Access Compliance Report

Public Rights-of-Way

(Curb Ramps)

Intersection ID: 28729	Main Street: AVENTIDE_LN	Cross Street: STEWARTS_CROSSING_DR	Location: NW
ADA ID: E4D92FC371B4	Ramp Type: BlendTrans1	Initial Pass/Fail: Fail	Overall Compliance: No
Severity Score: 10			
Codes/Mitigation Info/Possible Solution		Field Measurements/Component Compliance

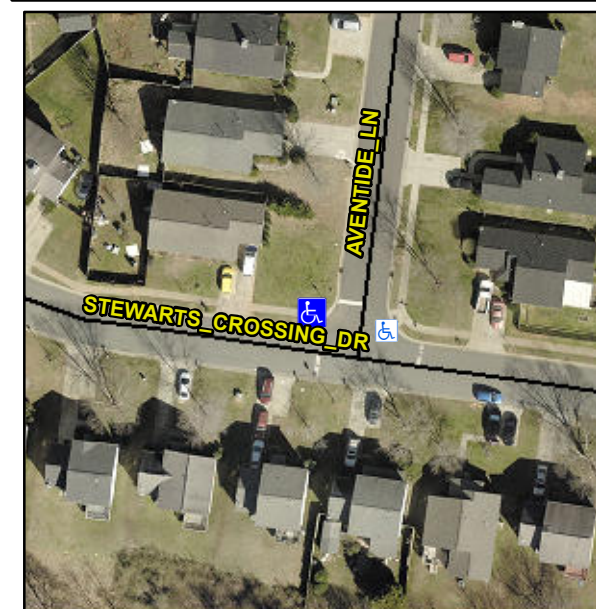
NO RT SW

Not Found, R304.5.1, R304.5.3

Compliance	Description	Data	Compliance	Description	Data
N/A	Ramp Length (in)	48.0	Yes	BlendTrans Slope (%)	4.3
No	Ramp Width (in)	37.0	No	BlendTrans XSlope (%)	3.3
N/A	Flare Type LT	N/A	N/A	Flare Type RT	N/A
N/A	Flare Slope LT (%)	N/A	N/A	Flare Slope RT (%)	N/A
N/A	Flare Traversable LT?	N/A	N/A	Flare Traversable RT?	N/A
N/A	Landing Length (in)	N/A	N/A	DWS Provided?	N/A
N/A	Landing Width (in)	N/A	N/A	DWS Contrast?	N/A
N/A	Landing Slope (%)	N/A	N/A	DWS Length (in)	N/A
N/A	Landing X Slope (%)	N/A	N/A	DWS Full Width?	N/A
N/A	Landing Curb? (Y/N)	N/A	N/A	DWS Offset (in)	N/A
N/A	Shared Landing?	N/A			
N/A	Gutter Ponding?	N/A	N/A	Gutter Slope (%)	N/A
N/A	Gutter Lip Ht (in)	N/A	N/A	Gutter X Slope (%)	N/A
N/A	Painted X Walk1?	No	N/A	Painted X Walk2?	N/A
	X Walk 1 Direction	To E		X Walk 2 Direction	N/A
	X Walk 1 Width (in)	N/A		X Walk 2 Width (in)	N/A
	X Walk 1 Slope (%)	4.8		X Walk 2 Slope (%)	N/A
	X Walk 1 X Slope (%)	2.7		X Walk 2 X Slope (%)	N/A

N/A	Ramp inside XWalk1?	N/A	N/A	Ramp inside XWalk2?	N/A
	Road Slope (%)	2.7		Clear Space?	N/A
	Road X Slope (%)	4.8	N/A	Clear Space to XWalk (in)	N/A
N/A	Any Obstructions?	N/A	N/A	Storm Grate/Utility Hazard?	N/A
	Obstruction Type			Storm Grate/Utility Type	
		N/A			N/A
			Yes	Surface Condition? (G/P)	Good
			No	Curb Slope (%)	22.2

Remove & Replace Curb Ramp With Two New Directional Ramps or Equivalent.
